PETITION OF GREENSKIES CLEAN ENERGY, LLC FOR A DECLARATORY RULING THAT A CERTIFICATE OF ENVIRONMENTAL COMPATIBILITY AND PUBLIC NEED IS NOT REQUIRED : PETITION NO. 1460
September 28, 2021

PETITIONER’S RESPONSES TO THE FIRST SET OF INTERROGATORIES BY THE CONNECTICUT SITING COUNCIL

SITE DETAILS
GOSHEN PV SOLAR FACILITY
GREENSKIES CLEAN ENERGY LLC
129 BARTHOLOMEW HILL ROAD
GOSHEN, CONNECTICUT

PHOTOVOLTAIC ARRAY
NOT TO SCALE

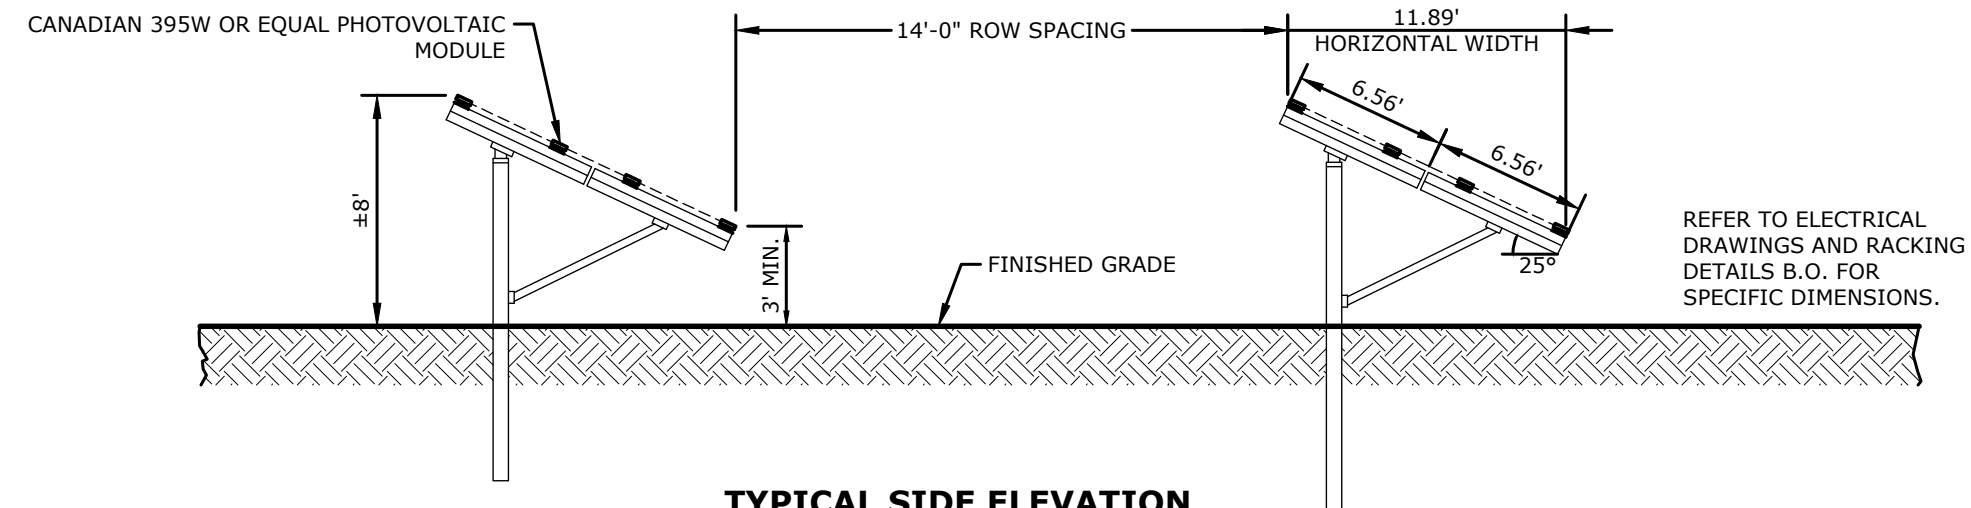
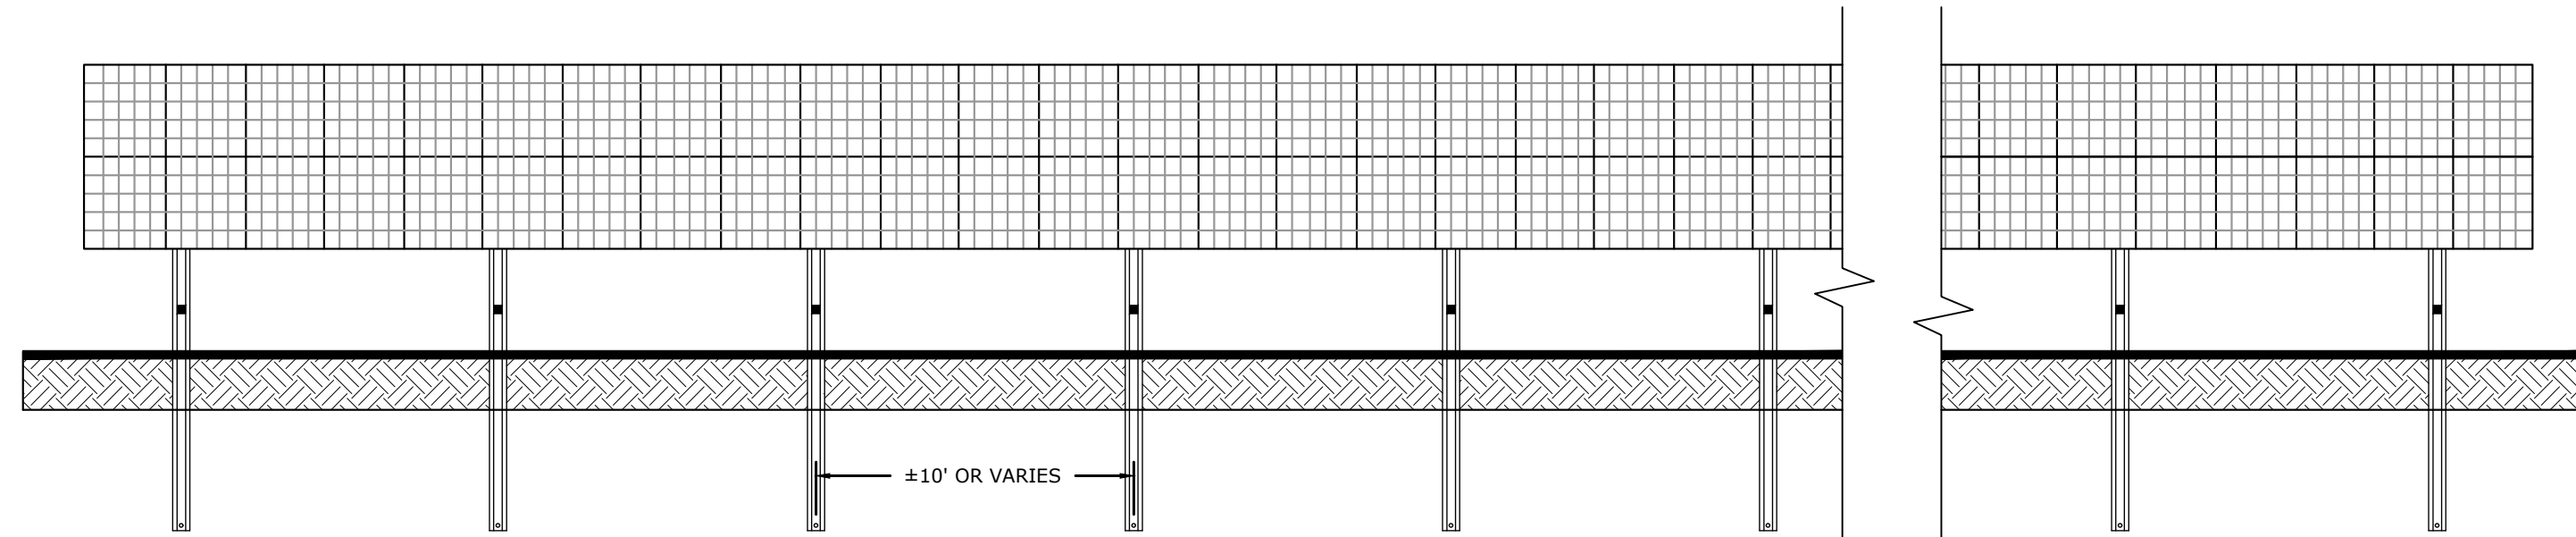
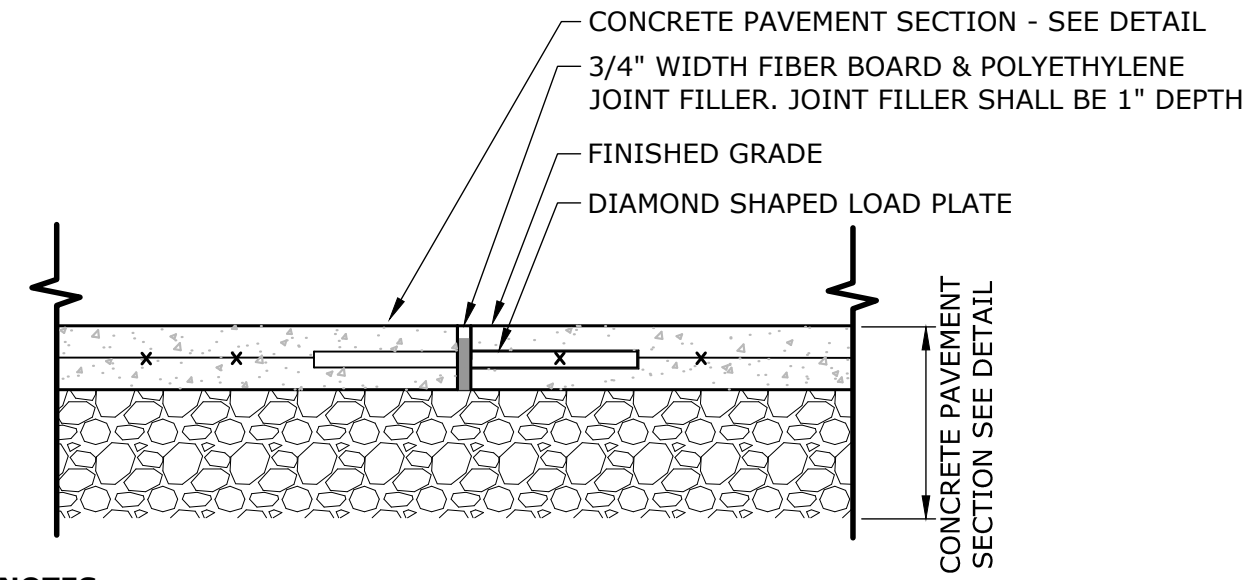
31. *The Site Plans specify a 14-foot wide aisle between the rows of panels. Detail Sheet SD-2 depicts a 13-foot wide aisle. Please clarify.*

Petitioner designed the aisles between the rows of panels to be fourteen feet wide. Petitioner has revised Detail Sheet SD-2 to show the correct width, which is appended hereto as Attachment 1.
